**DAVIS CANYON
DATA REVIEW AND COMMENTS**

APRIL 1986

HIGH LEVEL NUCLEAR WASTE OFFICE

Figure 6. Relationship between Lockhart basin, a gravity high, and seismic line locations. Modified from Kitcho et al., 1984.

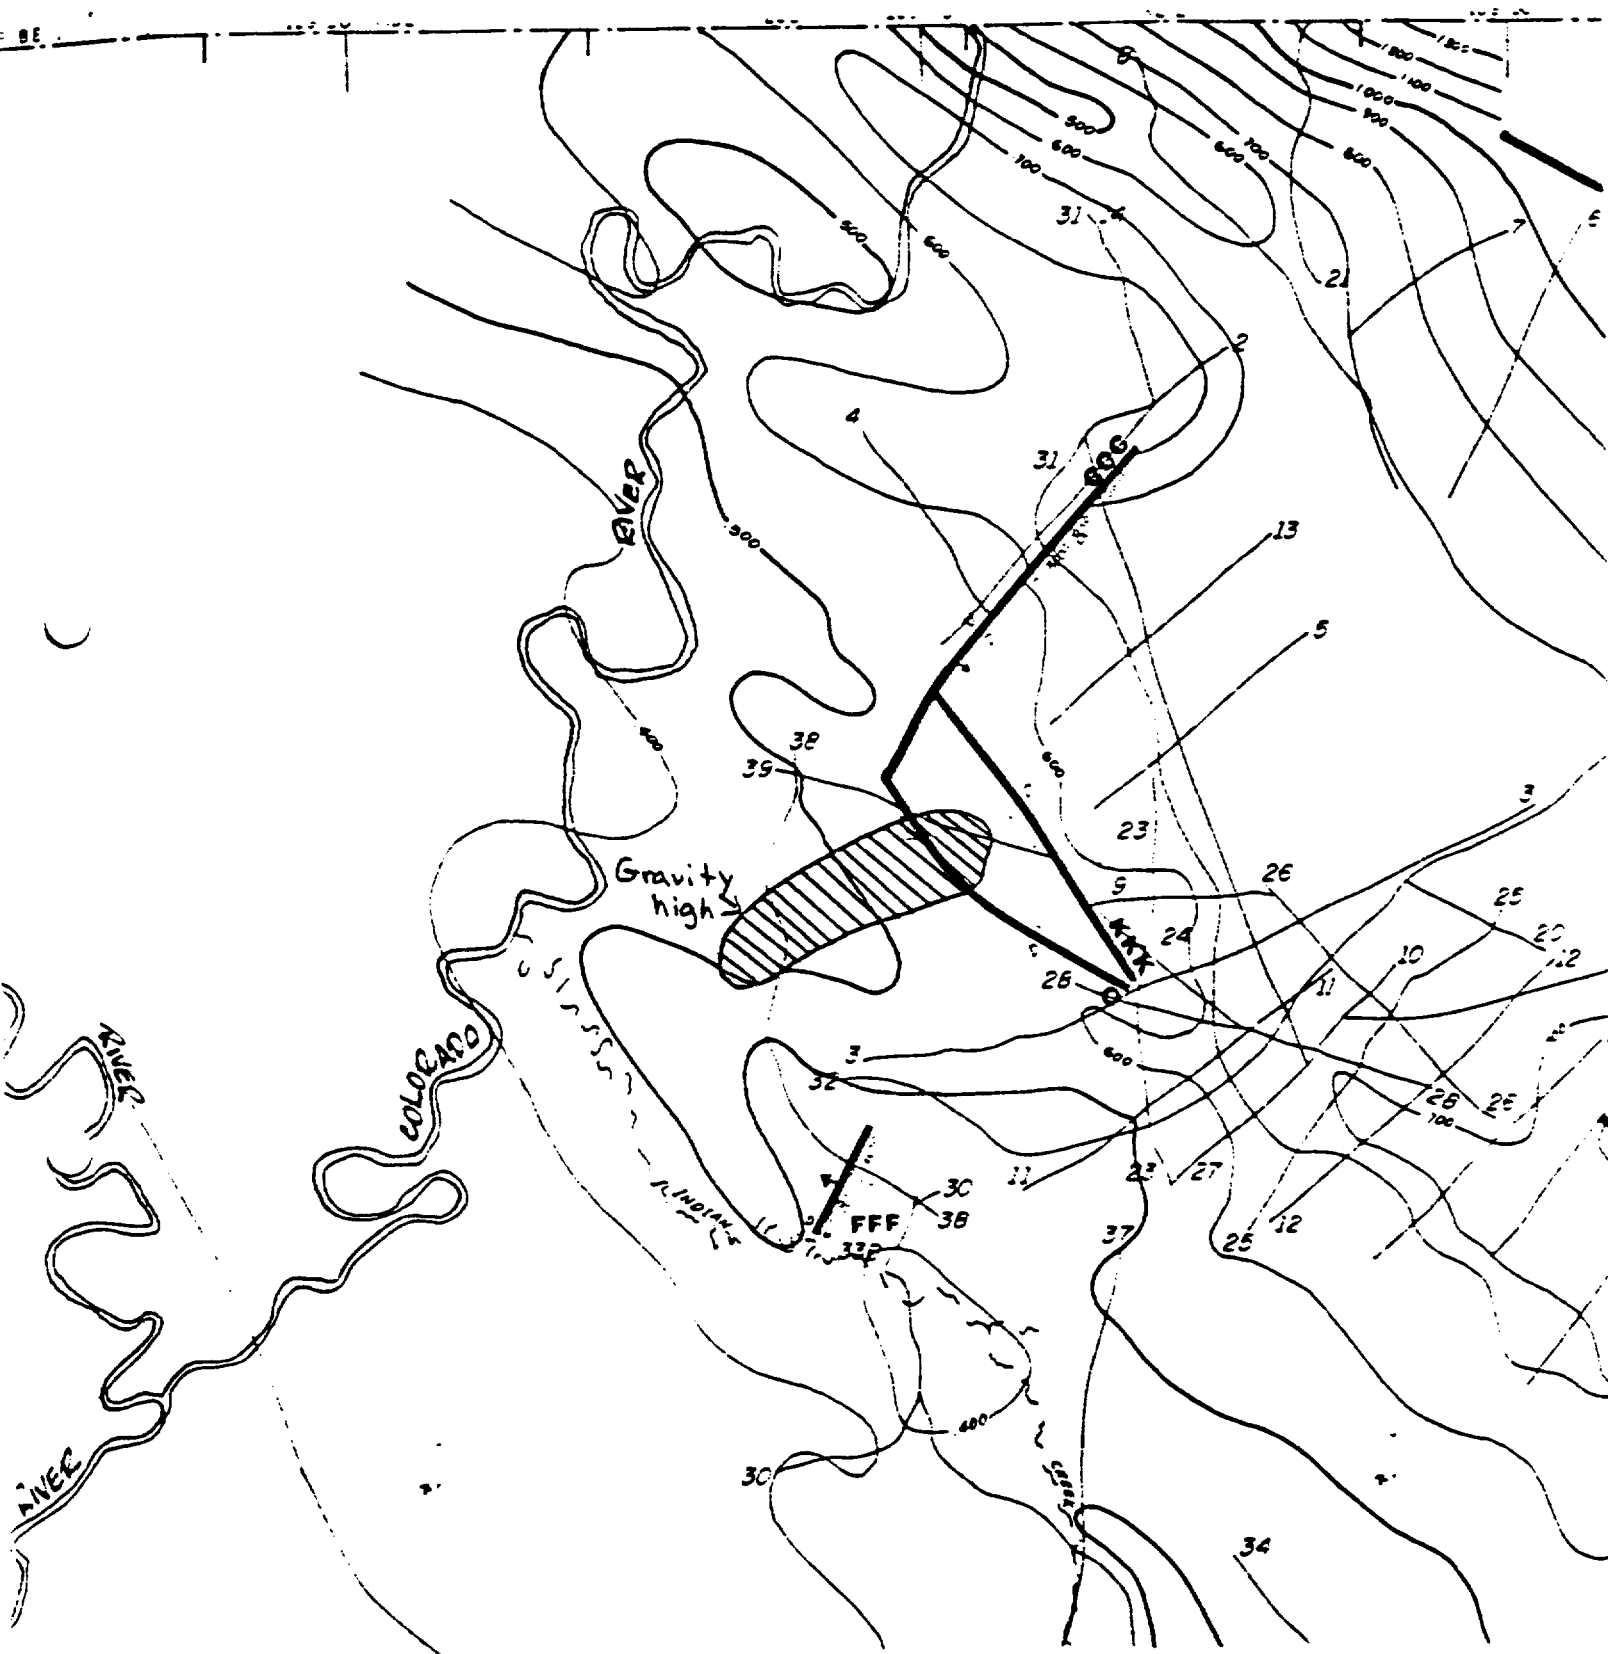
Our analysis of these geophysical interpretations in the Lockhart Basin area has identified many inconsistencies. Gravity anomaly A (discussed on page 19 and shown on Figure 5-5) is a gravity high over Lockhart Basin reflecting dissolution. The authors state on page 26 that "Fault O bounds the collapsed area in the subsurface" and that "the gravity high over Lockhart basin is attributed to the absence of salt." The gravity anomaly crosses south of Fault O, extends across seismic line 38, and is not centered over Lockhart basin. Kitcho et al. (1984) also states: "Seismic line 38 shows salt present along its entire length, yet the gravity anomaly which is supposed to indicate dissolution overlaps this line. These inconsistencies shown in Figure 6 indicate that the ability to identify dissolution features using geophysical means is limited by the resolving power of the seismic tools.
